C15-2011-0122
ROW-1066 1090
TP-012200-03-11

CITY OF AUSTIN
APPLICATION TO BOARD OF ADJUSTMENT
GENERAL VARIANCE/PARKING VARIANCE

KRUPP RESIDENCE
 3700 LAWTON AVENUE
 AUSTIN, TX 78731

Re: 3700 Lawton Ave
Lot 1, Blk 5, Oakmont Heights

1 SITE PLAN
 SCALE 3/32" = 1'-0"

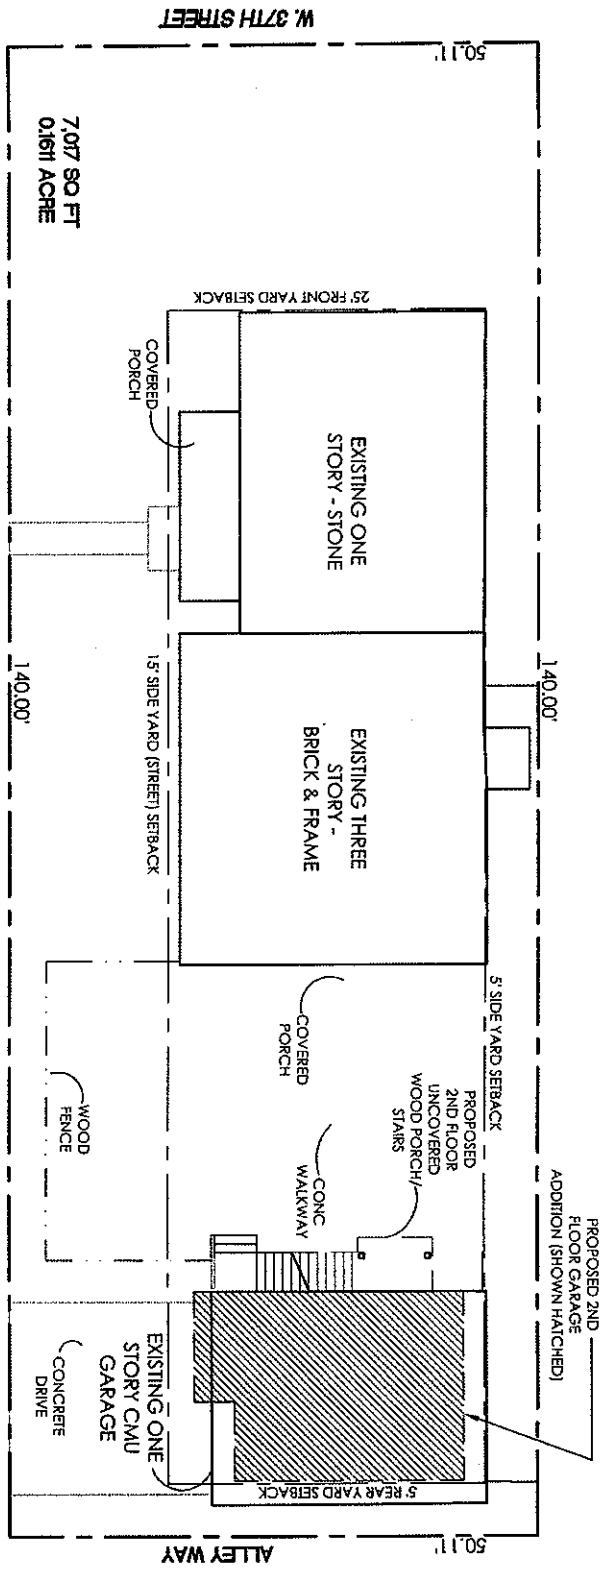
Austin Energy (AE) has reviewed your application for the above referenced property requesting to reduce the rear setback adjacent to the alley from 10 ft to 5 ft in order to erect a 2nd story garage apartment. Austin Energy has no conflicts with this application as requested and shown on the attached red-stamped sketch.

A site plan has reviewed this plan for
 and ~~approved~~ *disapproved* the various requirements under the Board of Adjustment. Any changes to
 this plan must be approved by Austin Energy.

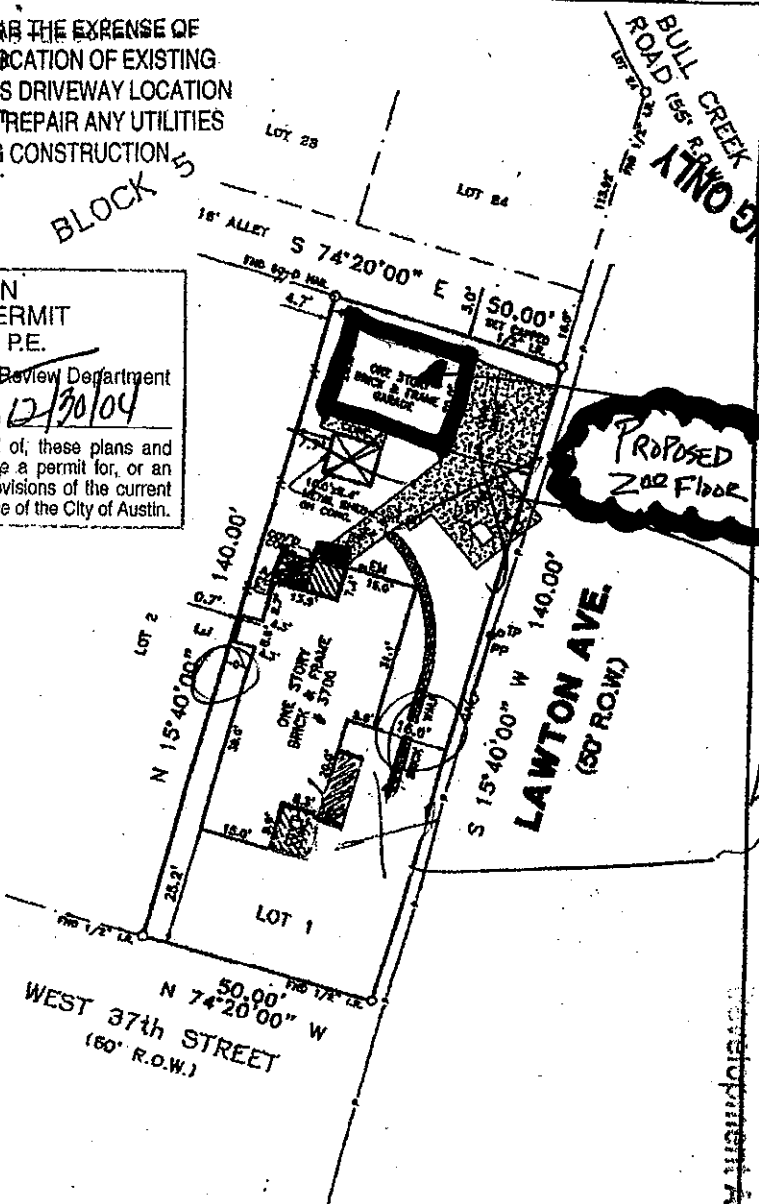
Delete concrete to concrete w/I.C
